HISTORIC AND DESIGN REVIEW COMMISSION

October 4, 2017

HDRC CASE NO: 2017-454
ADDRESS: 529 DEVINE ST
LEGAL DESCRIPTION: NCB 2957 BLK 1 LOT 19
ZONING: R-5, H
CITY COUNCIL DIST.: 1
DISTRICT: Lavaca Historic District
APPLICANT: Wade Lewis
OWNER: Wade Lewis
TYPE OF WORK: Window replacement
REQUEST:

Exhibit
B.

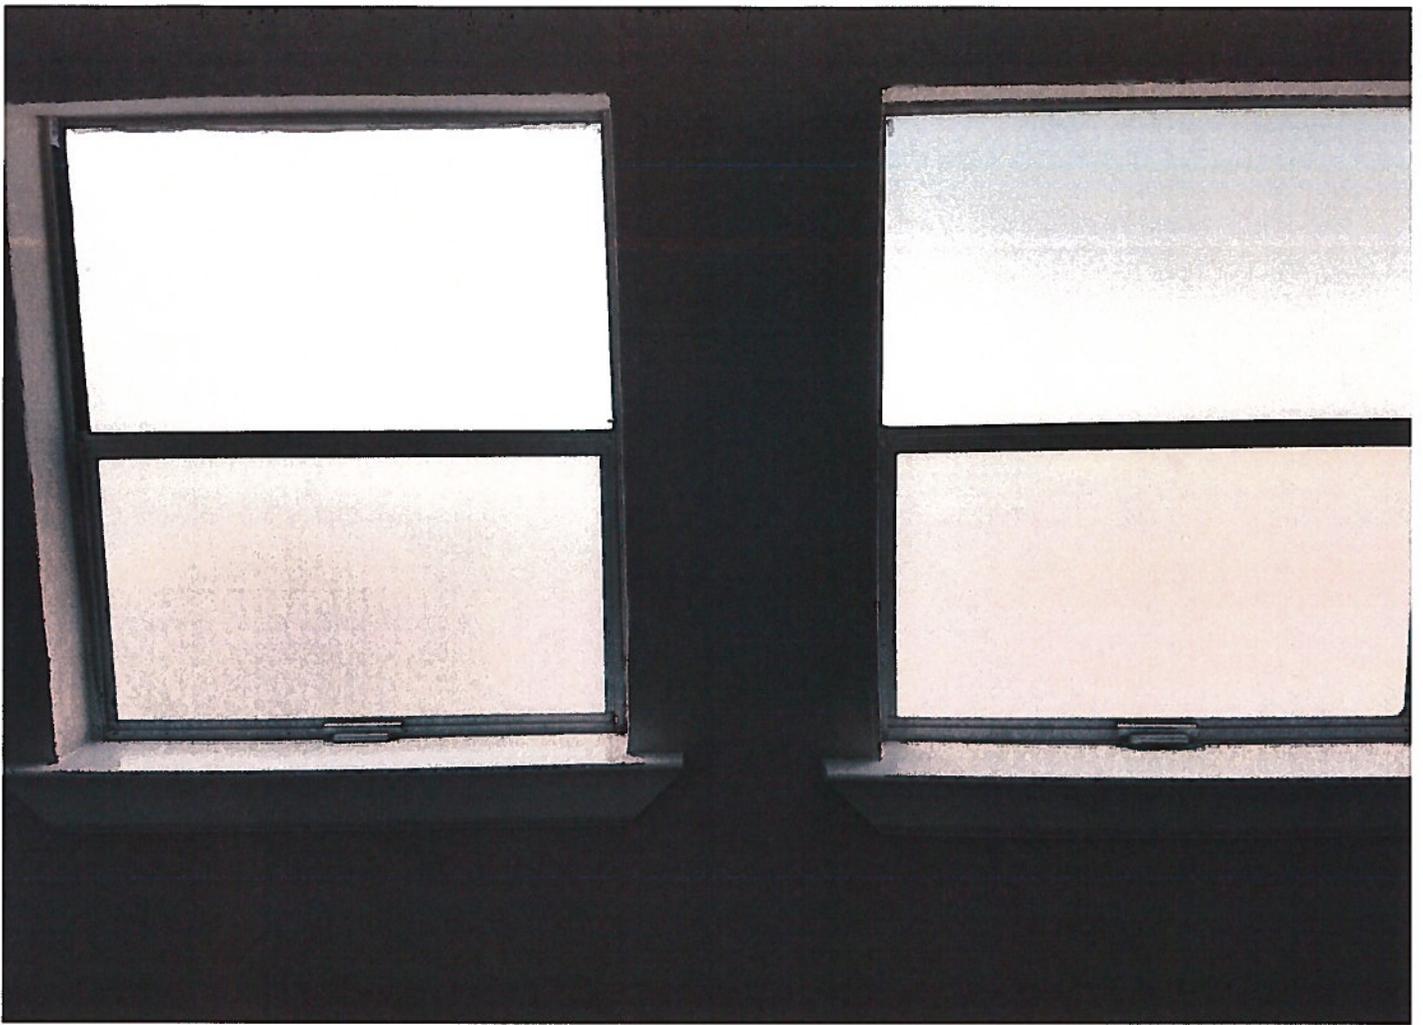
Window #3

To be replaced with vinyl window

window #4

Rotted siding to be replaced with like siding - 117 SYP Board

Staff does not recommend approval of item #1, the replacement of wood windows. Staff recommends that all existing wood windows be repaired and that the removed sashes be repaired and reinstalled in the house.

Staff recommends approval of item #2, the replacement of aluminum windows, with the stipulation that the profile of the proposed vinyl windows match that of the historic structure’s original wood windows and feature a framing depth that is consistent with the historic windows.
